TDECQ update:
Comments on proposals to add
threshold adjustment

802.3cd ad hoc, 28th February 2018

Contents: notes on the proposals to add threshold adjustment to TDECQ*

Slide 13 data

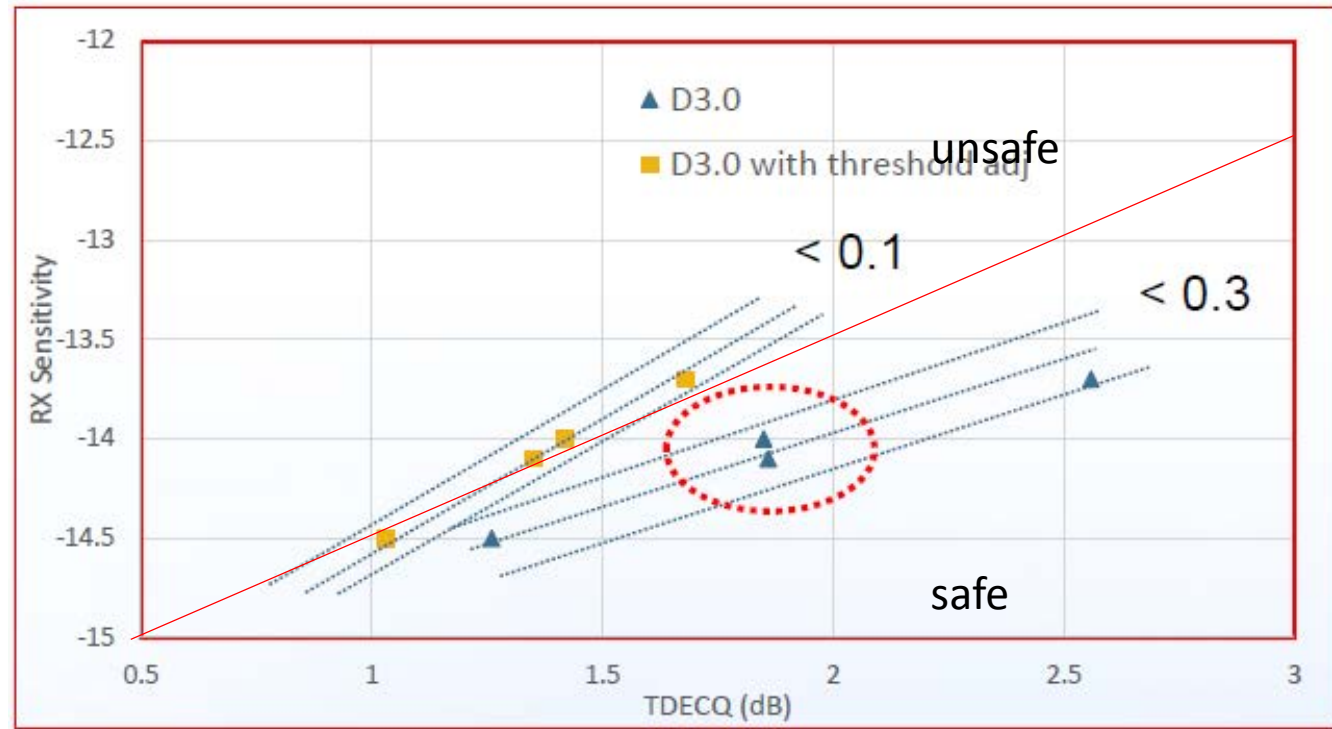
- When thresholds are optimized the slope of Rx sensitivity vs TDECQ is >1
 - This really would be a hole in the spec
- i.e. TDECQ with threshold adjustment underestimates receiver penalty, even though the receiver used has a much longer EQ (10 tap FFE) than the reference EQ
- In contrast, a reference EQ which is representative of the worst case receiver should tend to over-estimate sensitivity penalty (slope of receiver sensitivity vs TDECQ should be ≤ 1)
